BUILDING PERMIT REPORT

ADDRESS: 48 DAVID	_ <i>AD</i>	ingal dinasing a city. India dinasing dinasing	DATE: 22/NOV	191
RRASON FOR PERMIT:	replace	_ Addi Tio	res (esta Gravaria 🔻	I Tian
o nement representation in the so-	na sepa di Kapa da Piranga dikia	ada biy din bas		3775
BUILDING OWNER: MARY	-Ann En	aire		
CONTRACTOR: Dans	d Duft	030 E		
PERMIT APPLICANT: //	usqn sil nusa i	endardija obočenja	ktestanog A 190	
APPROVED: X	6 ×7	*/2		Seagge and extremely
CONDITION OF APPROVAL:	the state of the s		- Variation (C.) Establish Salbaron (A.) Haldarija	**************************************

BEPLACE WITH
MEN 12x1x PEMOVE OLD 12'XIY' FOOM OEPT OF BUILDING INSPECTIONS Novo 8 1991 2 DAVID RD 48 DAVID ログノカニメル してのと MAYER ďЯ

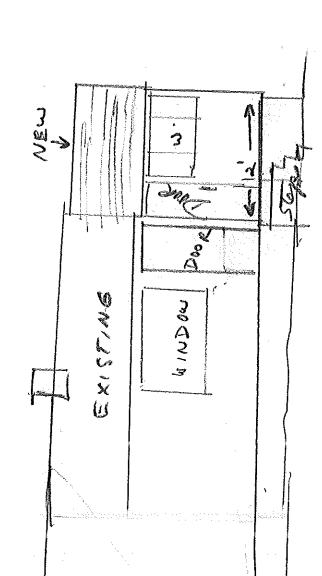
- 1.) Before concrete for foundation is placed, approvals from Public Works and Inspection Services must be obtained.
- 12.) Precaution must be taken to protect concrete from freezing. o sant la celle de celle de lace lace lace de la lace l

- √ 6.) Every sleeping room below the fourth story in buildings of Use Groups R and I-1 shall have at least one operable window or exterior door approved for emergency egress or rescue. The units must be operable from the inside opening without the use of separate tools. Where windows are provided as a means of egress or rescue, they shall have a sill height not more than 44 inches (1118 mm) above the floor. All egress or rescue windows from sleeping rooms must have minimum net clear openings of 5.7 square feet (0.53m2). The minimum net clear opening height dimension shall be 24 inches (610 mm). The minimum net clear opening width dimension shall be 20 inches (508 mm).

- 7.) All single and multiple-station smoke detectors shall be of an approved type and shall be installed in accordance with the provisions of the building code (BOCA National Building Code 1990, and N.F.P.A. 74).

- 9.) A guardrail system located near the open side of deck or elevated walking surfaces shall be constructed. Guards in buildings of Use Group R-3 shall be not less than 36 inches in height. Open guards shall have intermediate rails, balusters or other construction such that a sphere with a diameter of 4 inches cannot pass through any opening. Handrails on stairs shall be no less than 34 inches nor more than 38 inches. Handrails within individual dwelling units shall not be less than 30 inches nor more than 38 inches. unitarist docimentario de la company de
